INITIAL FIRE SAFETY INSPECTION REPORT

That's It Fashion Ltd-Extension (Previously Peak Apparels)

RSC ID: 25772

Date: 08-October-2024

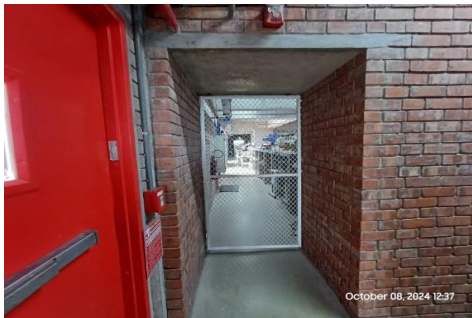
Sl No.	Category	Findings	Required Action	Remediation Time Frame
F-01	Fire Rated Construction	Rooms used for combustible storage are not separated by fire rated construction Location: Ground, 1st and 6th (Idle machine store) floors.	Separate the dedicated storage rooms by minimum 1-hr fire-rated construction. Provide 0.75 hr. fire rated door and seal all penetrations and openings by 0.75 hr. (45 Minutes) fire rated barrier construction.	Within 3 months
 The table includes three photographs illustrating the findings. The first two photos show long aisles in a warehouse with high shelving units filled with cardboard boxes, indicating combustible storage. The third photo shows a doorway leading to another storage area, with a fire-rated door and wall visible, suggesting the need for fire-rated construction to separate storage rooms.

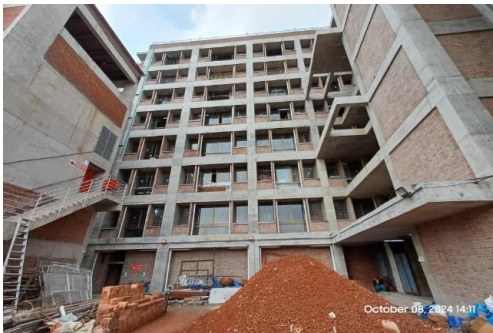
F-04	Fire Rated Construction	Elevator shafts are directly open into the production floor without proper fire separation. Location: Each floors.	Provide a minimum 2-hr fire rated elevator shaft to separate it from each floor. Seal all openings to maintain fire separations. Factory is recommended to follow RSC published "SUPPLEMENTARY PAPER ON REMEDIATION GUIDANCE ELEVATOR OR LIFT SHAFT OPENING IN EXIT ENCLOSURES" for different solutions.	Within 3 months

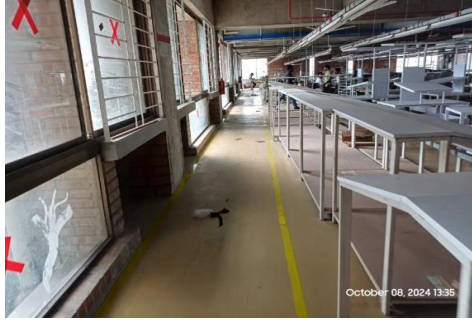
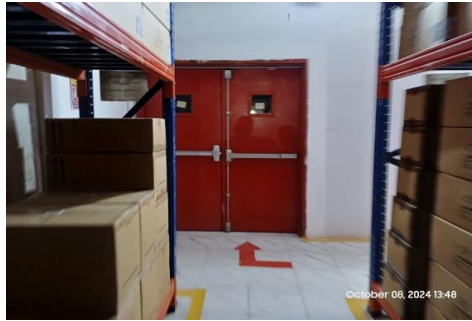
F-08	Means of Egress	Handrails are not provided on both sides of exit stairs. Location: Stair-4 exit discharge.	Provide handrails on both sides of the exit stair. New handrails shall have a minimum height of 865 mm (34 in.) and a maximum height of 965 mm (38 in.) as measured from the leading edge of the tread. Intermediate handrails shall be provided when the stair width exceeds 2.2 m (87 in.).	Within 3 months

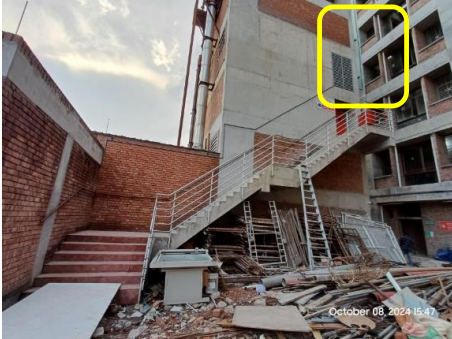
F-18	Means of Egress	Based on the number and location of emergency lights observed, adequate illumination levels are not anticipated along egress routes. Location: Each floors.	Test the emergency lighting system on each floor and provide additional emergency fixtures to supply adequate illumination along the means of egress. Provide a minimum illumination of 10 lux at the floor level within exit stairs and along exit discharge paths and a minimum 2.5 lux along exit access aisles.	Within 1 month
